**TO:** PERMIT FILE FOR AMERICAN CEMENT #0902-M3  
**FROM:** REGAN EYERMAN, ENVIRONMENTAL HEALTH SCIENTIST  
**SUBJECT:** PHONE MESSAGE WITH VERN CHOQUETTE, PRINCIPAL CONSULTANT, TRINITY CONSULTANTS  
**DATE:** 3/19/2009

To: Regan Eyerman, Environmental Health Scientist  
From: Jeff Stonesifer, Senior Environmental Health Scientist *JWS*  
Subject: Review of model for American Cement Corporation  
Permit # 0902-M3

**Date:** March 23, 2009  
**To:** Jeff Stonesifer, Senior Environmental Health Scientist  
**From:** Regan Eyerman, Environmental Health Scientist RVE  
**Subject:** Execute Air Dispersion Modeling for American Cement Corporation. (permit # 0902-M3) to determine compliance with the NAAQS and NMAAQs for TSP, PM<sub>10</sub>, and PM<sub>2.5</sub>.

American Cement Albuquerque Terminal  
 TSP annual with Holly haul road and rural disp coeff  
 C:\DispModeling\Sources\American Cement 0902-M3\js\_review\TSP\amerCmt\_0902-MS\_1986\_TSP.GRF

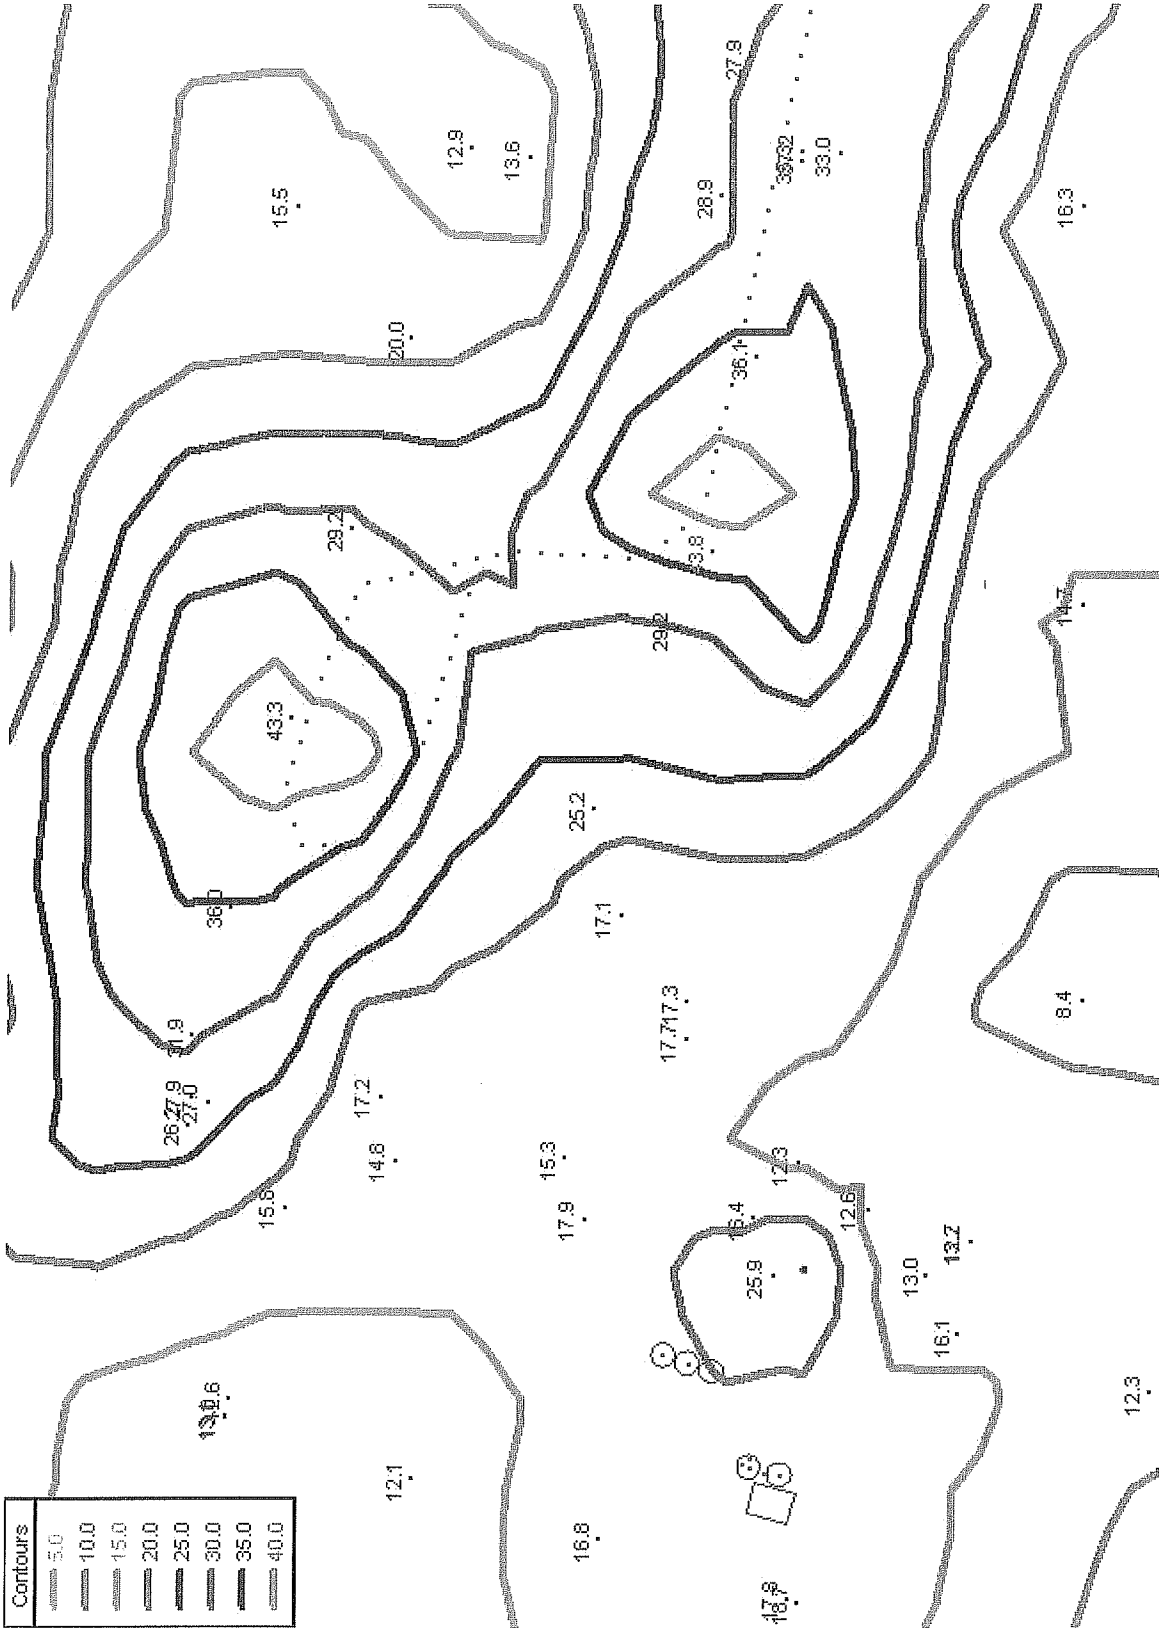
The model submitted used urban dispersion coefficients. The Air Quality Division (AQD) encourages the use of rural dispersion coefficients, as opposed to urban numbers, because it results in higher impacts. If the use of rural dispersion coefficients results in a violation of the standards, then modelers should go back and investigate whether it's appropriate to use urban coefficients. Because there was no analysis to defend the choice of urban numbers (i.e. using urban was a subjective decision), it's more defensible to simply use the rural numbers.

To settle any concerns over the use of urban vs. rural coefficients, the model was re-run with rural numbers. The results are listed in Table 4 and are well within NAAQS and NMAAQs.

In the modeling report submitted, a TSP/PM10 background of 31 was used. AQD Modeling Guidelines show a background value of 35 is correct. The results in Table 4 reflect a background value of 35. PM10 results are not listed because the 24-hour TSP result demonstrates compliance for the 24-hour PM10 standard. Because the TSP model demonstrates compliance for PM10 also, the PM10 emission rates listed in Table 1 are the same as the TSP emission rates.

In the cumulative TSP model, the haul road for Holly Asphalt was modeled with adjacent volume sources of the following dimensions: horizontal dimension = 2.79 meters; release height of 2.5 meters and vertical dimension of 2.32 meters. The horizontal dimension implies a road width of about 20 feet. The vertical dimension and release height match up and fit small to medium size truck traffic. The dimensions of the volume sources used for haul road modeling are fine.

According to permit #559-M3, TSP minus PM10 emissions equals 5.7 lb/hr. The 0.6 hourly emissions factor can be further used to reduce the supercoarse particle emissions from 5.7 lb/hr to 3.4 lb/hr. The emissions from the individual haul road volume sources in the model sum up to 0.59 lb/hr. AQD inquired about this discrepancy and Trinity Consultants provided an explanation. Using updated AP-42 data, Trinity re-calculated the emissions from the Holly haul road as 0.95 lb/hr. The 0.6 hourly emissions factor was then used to reduce the 0.95 lb/hr rate to 0.59 lb/hr.

The AQD should accept the model submitted for permit 0902-M3.
